SERVICE INSTRUCTION

EQUIPMENT: RT-406F

INSTRUCTION NUMBER: WSI RT-406F-5 Revision A

To reduce harmonics from the receiver 2nd LO which improves sensitivity at 450 MHz.

Figure 1

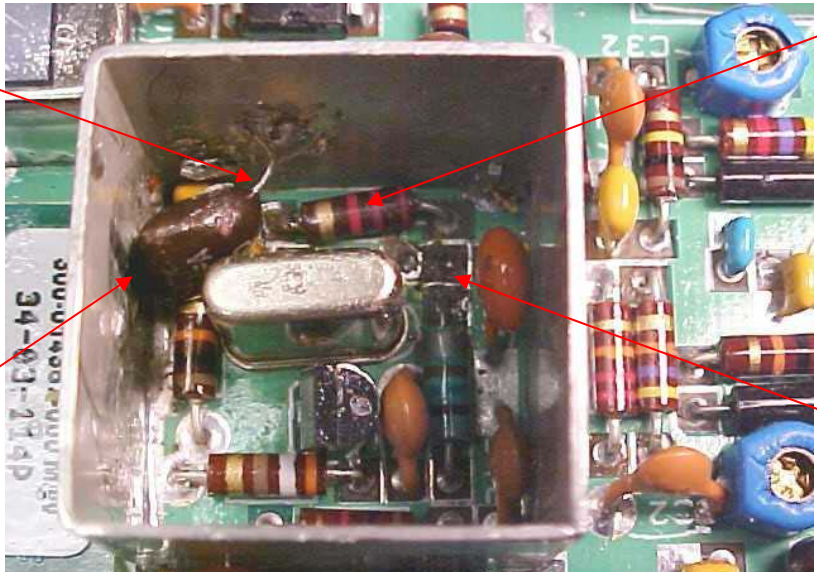
1. Remove the receiver assembly cover.
2. Locate and remove C43. See Figure 1.
3. Cut both legs of Item 1 to .2". Solder one leg of Item 1 (C500) to R32 junction. Solder the other leg of Item 1 (C500) to the adjacent shield. See Figure 1.
***NOTE:** Capacitors are test select.
4. Solder one end of Item 2 (R500) from the center conductor of the Guard Receiver input coax of PS1. Solder the other end to the adjacent shield. See Figure 2.
5. Verify 2nd L.O. stage has oscillation on pin 12 of U13. Use appropriate C500* as required.
6. Reinstall the receiver assembly cover. Reassemble the RT-406F.

Figure 2

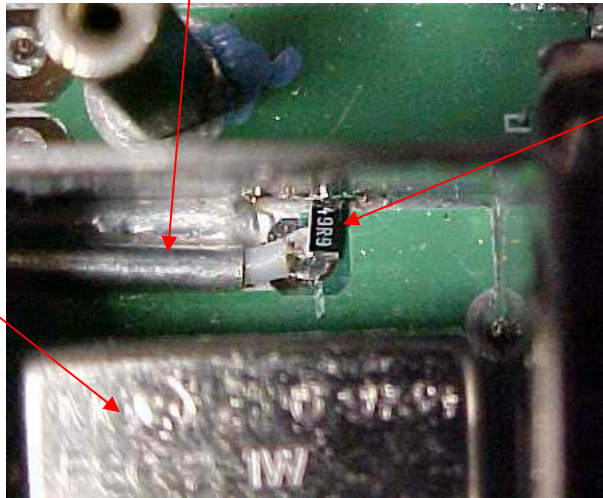
This modification adds a resistor on the Guard Receiver input coax and a test select capacitor in the oscillation circuit.
